Addendum #3 Solicitation # 20-10AA Project: Hot Water Distribution System Balance of Plant (Mechanical) at Duluth Energy Systems

This addendum serves to notify all bidders of the following changes to the solicitation documents:

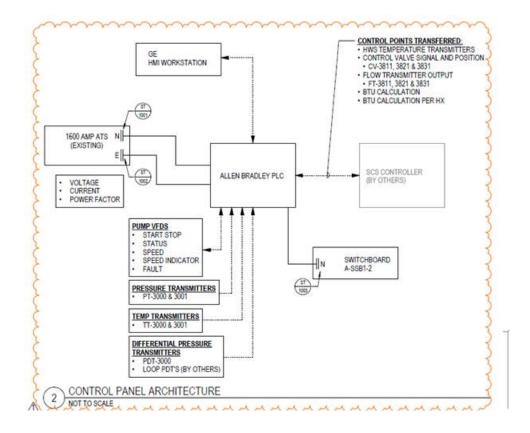
Below is clarification of the scope limits of the "steam header" and "steam train" furnish and install. Defined as follows:

- 1. As shown in the construction drawings and P&IDs, the "steam header" is the section of main steam header from the building west wall face, extending into the building at the 'Steam Deck' level. This header has (4) take-offs; three of which will have attached the "steam trains". The 4th take-off will be valved and capped for future:

- a. Furnished by: Campbell-Sevey (as part of previous contract).
 - b. Supported by: Structural steel provided by this contractor.
 - i. As part of contract: 20-10AA Balance of plant mechanical (<u>this</u> contract)_____

- c. Installed by: <u>This</u> contractor_
 - i. As part of contract: 20-10AA Balance of Plant mechanical (<u>this</u> contract)
- "Steam trains" are the sections of branch steam rising up from the "steam header" on the steam deck, then turning horizontal and running south to their respective SCS-1, 2 and 3 PHX inlets. These trains have all the devices required to control steam delivery to their respective SCS – as detailed in the plan/elevation drawings and P&IDs:

- a. Furnished by: Campbell-Sevey (as part of previous contract).
 - b. Supported by: Structural steel provided by this contractor.
 - i. As part of contract: 20-10AA Balance of plant mechanical (<u>this</u> contract)_____

- c. Installed by: <u>This</u> contractor.

i. As part of contract: **20-10AA Balance of Plant mechanical** (<u>this</u> **contract**)
